Re: Revolution Wind COP EIS; Docket No. BOEM–2021–0029

The Rhode Island Coastal Resources Management Council (RICRMC) is providing the following comments as a cooperating agency in the preparation of the above referenced EIS for the Revolution Wind offshore project located within BOEM Lease Area OCS-A 0486.

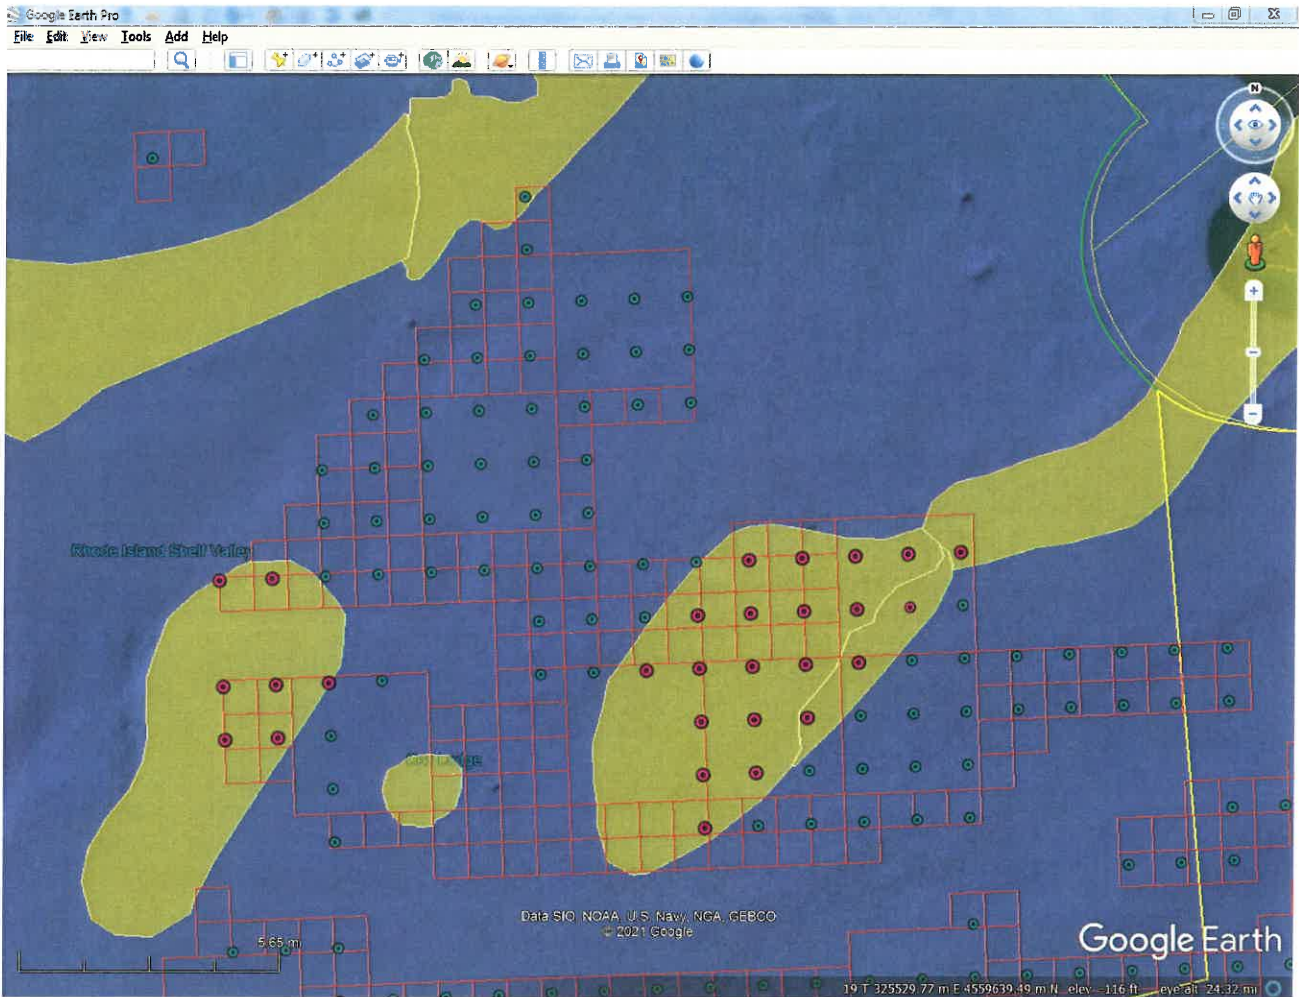
1. Pertaining to the current Revolution Wind project, BOEM should be aware of the RICRMC enforceable policies for Areas of Particular Concern (APC) that presumptively exclude all offshore development, as defined at 650-RICR-20-05-11.10.1(A), within APC. The RICRMC has preliminarily identified multiple turbines located within areas of the Revolution project boundary that meet the characteristics and definition of APC as identified in state waters. Specifically, these preliminarily identified turbines are located in areas identified as glacial moraine. Accordingly, the RICRMC believes that the project can be modified to avoid the installation of offshore development within these areas of glacial moraine and still meet the purpose and need for the proposed project as described within the Revolution Wind Construction and Operations Plan (COP).

The RICRMC enforceable policy at § 11.10.2(B) states in part “*All large-scale, small-scale, or other offshore development, or any portion of a proposed project, shall be presumptively excluded from APCs.*” The Revolution Wind project is partly located on a terminal glacial moraine which is defined as a high boulder hazard area. See Revolution Wind COP at section 4.2.3. In accordance with Ocean SAMP enforceable policy § 11.10.2(C)(3) glacial moraine are defined as APC because they contain valuable habitats for fish and other marine life that are important to commercial and recreational fishermen. See APC definition at § 11.10.2(A). CRMC staff have tentatively identified upwards of 28 Revolution Wind turbine foundations and associated inter-array cables located within glacial moraine as shown in Figure 1 (Appendix A). Figure 1 is based on the proposed Revolution Wind turbine foundation layout, which is aligned with the wind industry’s

November 2019 proposed 1 x 1 NM uniform grid wind farm layout. The currently proposed Revolution Wind project has not sited foundations and inter-array cables to avoid areas of glacial moraine. All offshore development is presumptively excluded from CRMC designated APC pursuant to the CRMC enforceable policy at § 11.10.2(B). This exclusion, however, is rebuttable if the applicant can demonstrate by clear and convincing evidence that there are no practicable alternatives that are less damaging in areas outside of the APC, or that the proposed project will not result in a significant alteration to the values and resources of the APC.

The CRMC enforceable policy at § 11.10.2(B) requires the developer to demonstrate that "all feasible efforts have been made to avoid damage to the APC resources and values." Given the currently proposed layout of the 100 turbines, it is our determination that the developer has not demonstrated that "all feasible efforts" have been made to avoid damage to the APC resources and values. There are approximately 28 turbine foundations identified at this time that are proposed within glacial moraine that could be relocated and not impact the developer's ability to meet the project purpose for the Revolution Wind project to provide 704 MW under the current contractual agreements.
